Swan_soundbar

DVT3_Assembly review

ALT Co., Ltd.

Issued Date 2021.08.30

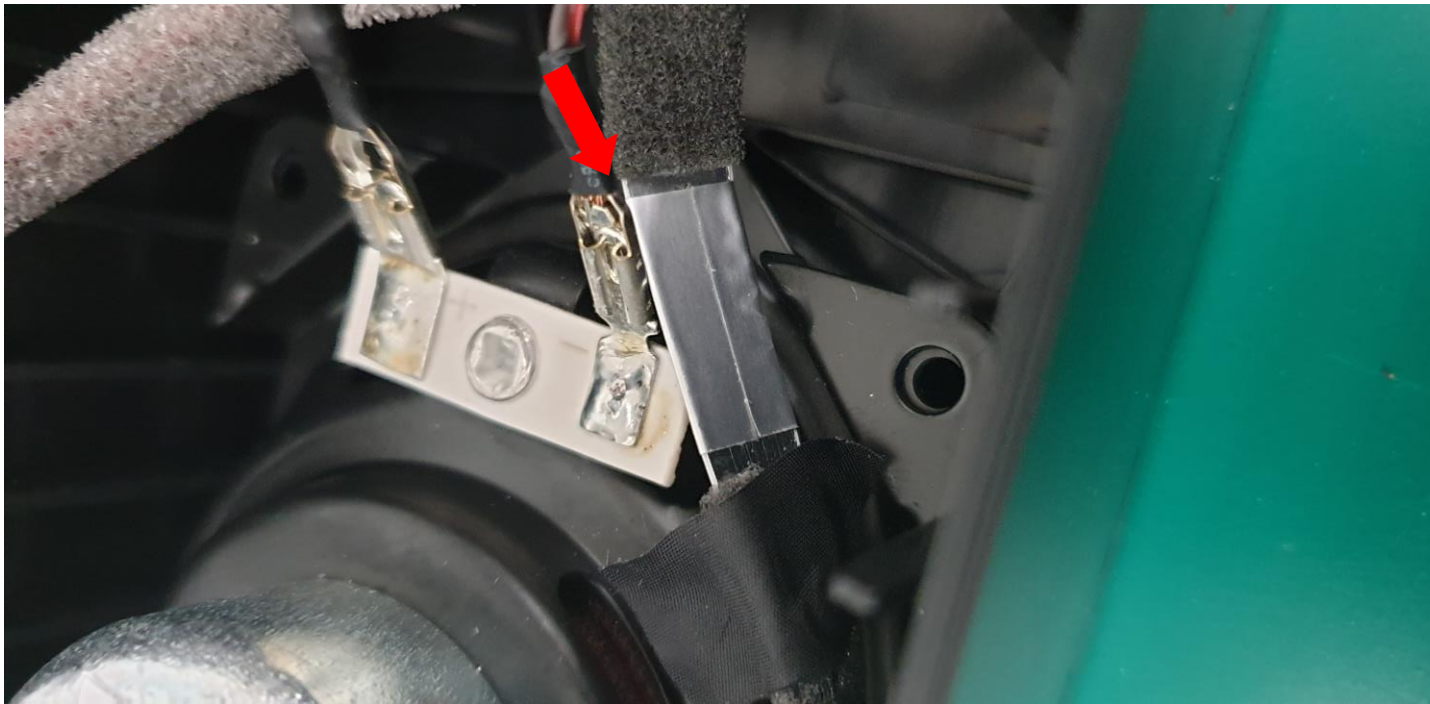
- Cable routing caution

- It may can touch side FFC GND with Speaker signal connector

No booting issue_J4 contact issue

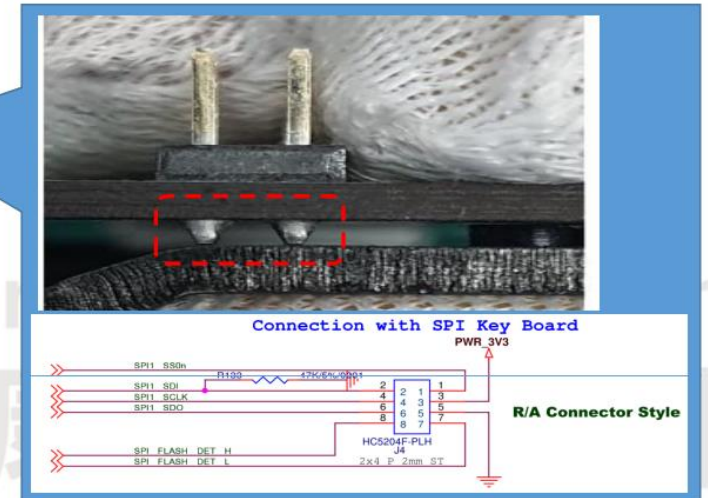
- The J4 is touch with bottom spreader
- DFM ISSUE :

1. The J4 is used for debug port of VS550
2. The J4 pin header is very close to the bottom heat spreader of main board. If J4 is in contact with the heat spreader, the main board may not bootup properly because the 3.3V power short-circuited to ground
3. The leg of pin header changed to normal type in DVT3 build in order to solve the soldering issue on ground pin of pin header. And we will change the pin header to short leg type in MP to prevent the risk of short issue after assembly.
